RIDGE PORT NORTH 4TH ADDITION

WICHITA, SEDGWICK COUNTY, KANSAS

RE: SUB 2001-20 -- Final Plat of Ridge Port North Fourth Addition

CASE NUMBER: SUB 2001-20 -- RIDGE PORT NORTH 4TH ADDITION

RIDGE PORT NORTH 4TH ADDITION

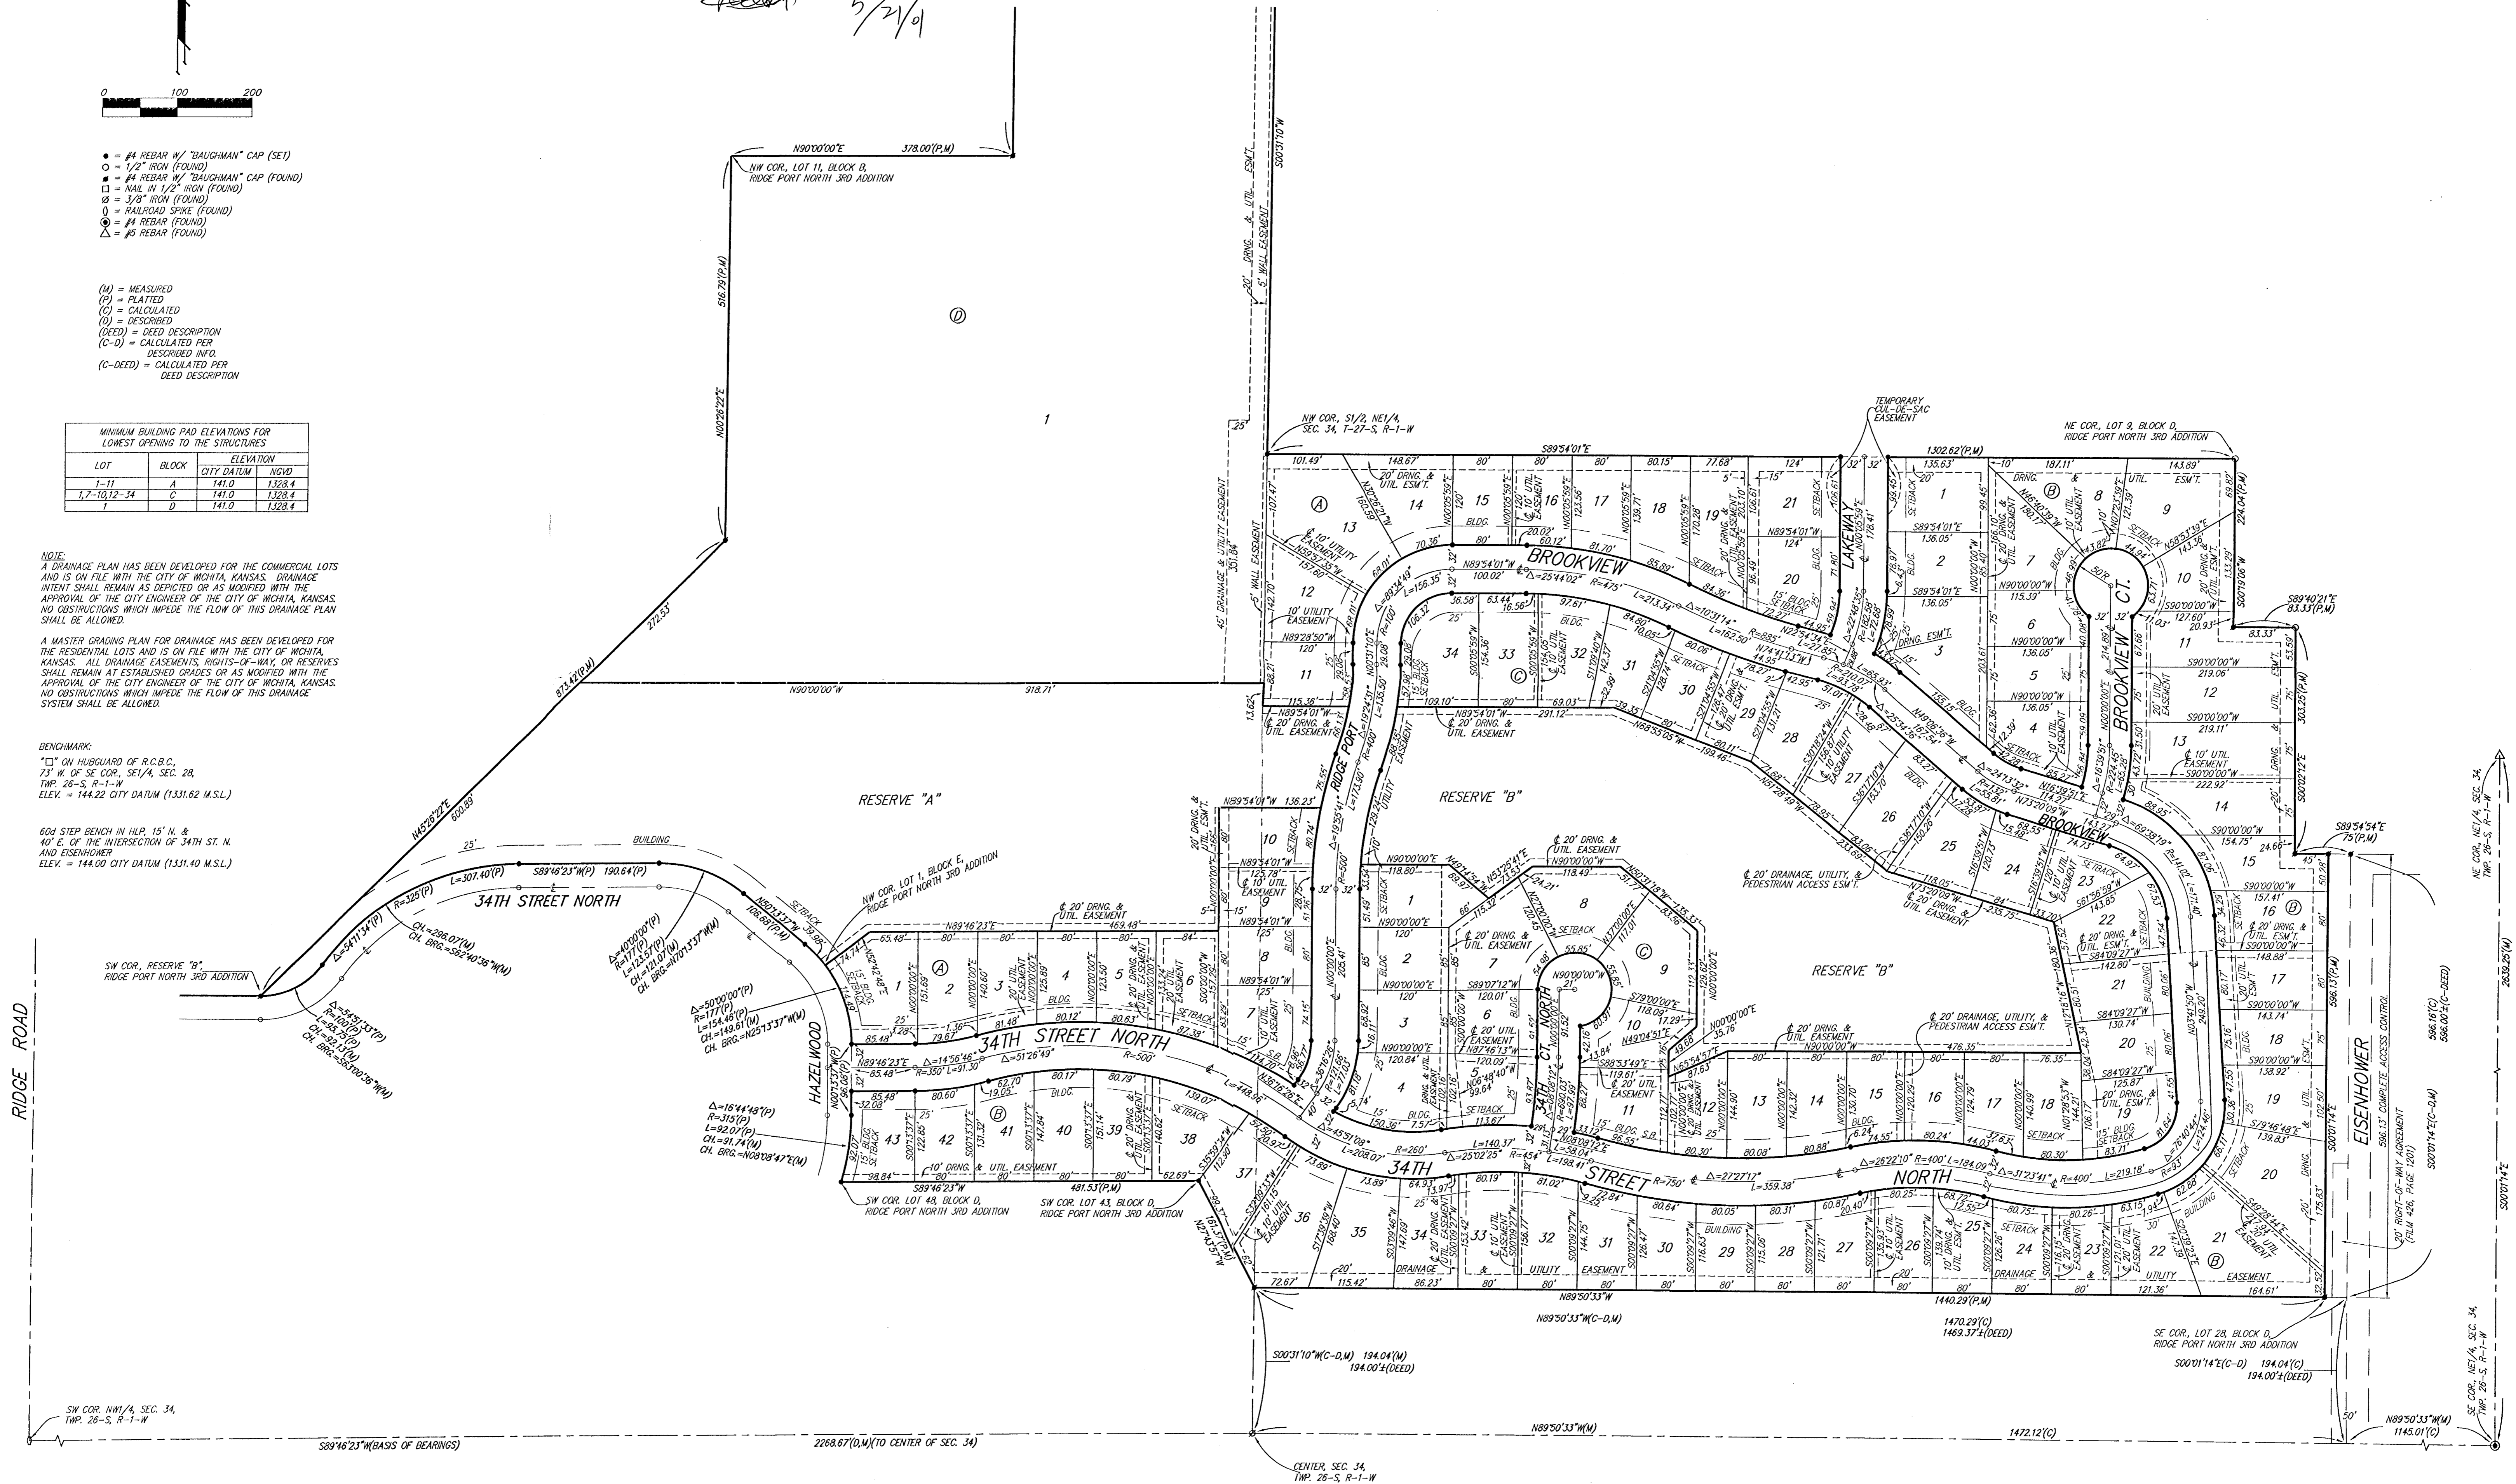
- L. It is recommended that Reserve B be extended to 34th North Court and the loop street by access easements or by narrow strips of Reserve between the lots to increase its accessibility and usefulness for all homeowners in the Addition. *The applicant has platted pedestrian access easements on the final plat between Lots 25 and 26 and between Lots 15 and 16.*

- M. The bench mark description needs to be corrected.
- N. The plat's text shall include language that a drainage plan has been developed for the plat and that all drainage easements, rights-of-way, or reserves shall remain at established grades or as modified with the approval of the applicable City or County Engineer, and unobstructed to allow for the conveyance of stormwater.

- V. The representatives from the utility companies should be prepared to comment on the need for any additional utility easements to be platted on this property. *KGE requests additional easements.*
